UNITED STATES PATENT AND TRADEMARK OFFICE

APPLICATION NO.	FILING DATE	FIRST NAMED INVENTOR	ATTORNEY DOCKET NO.	CONFIRMATION NO.
10/685,009	10/14/2003	Michael D. Gerdes	HE 8698US	4282

Office Action Summary	Application No. 10/685,009	Applicant(s) GERDES ET AL.	
	Examiner Travis M. Reis	Art Unit 2859

DETAILED ACTION

Attachment A

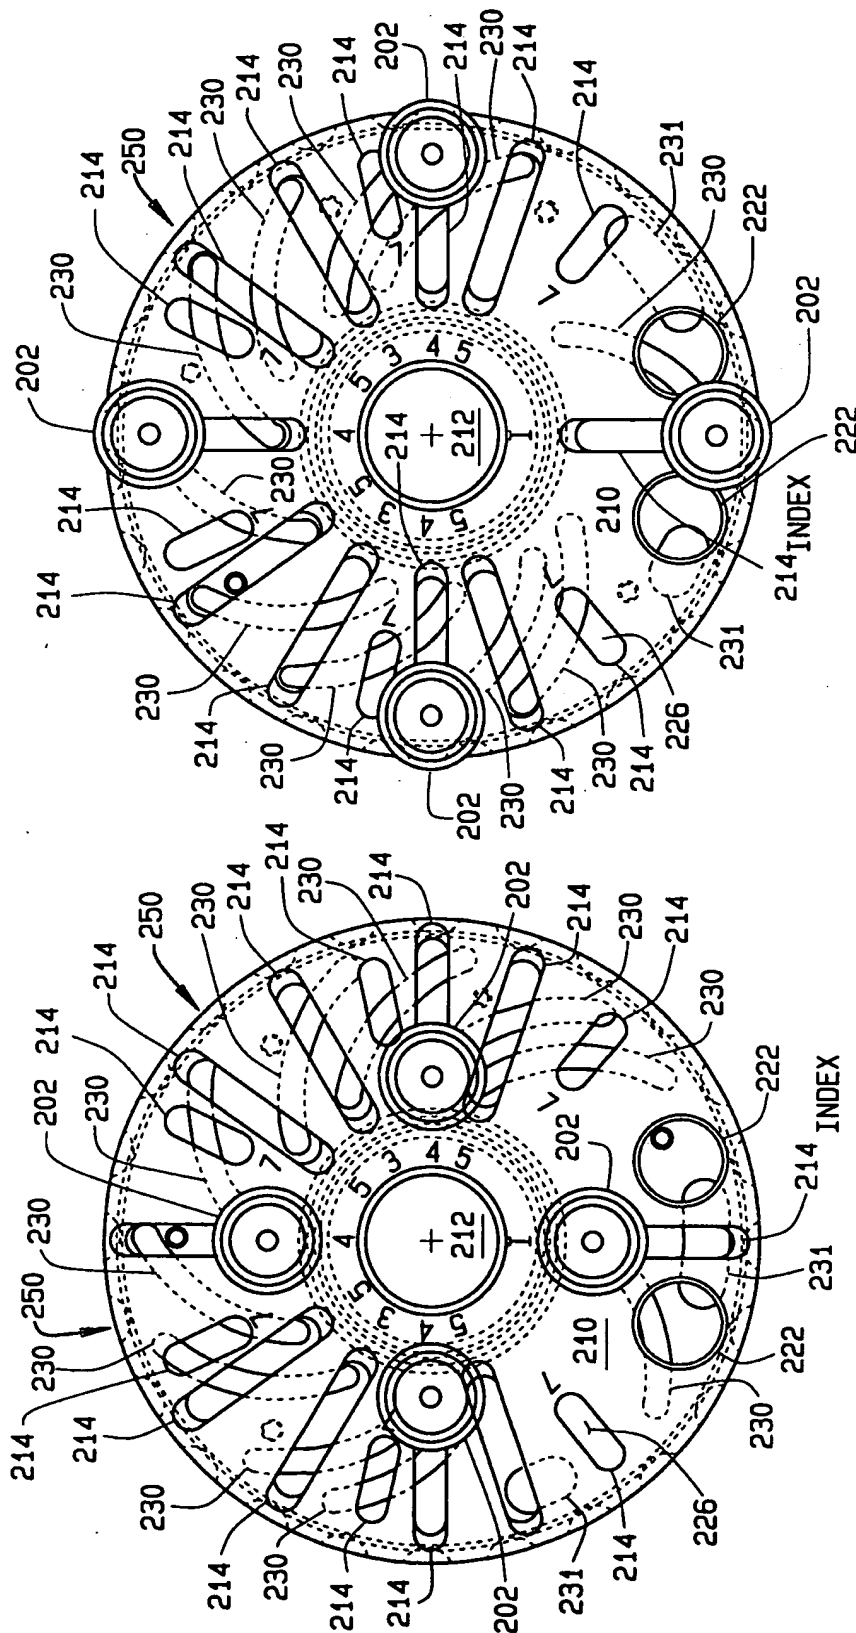
5. In response to applicant's arguments that the replacement of individual mounting flange plates disclosed by Mitchell with a singular plate disclosed by Warkotsch would result in a non-functional system and the illustration of combined mounting plates show that said plates cannot be combined; these arguments have been fully considered but they are not persuasive since as

shown in attachment A, the combination of the 3-slot configuration and the 4-slot configuration shows negligible intersection of slots and thus is a fully functional multiple-configuration plate.
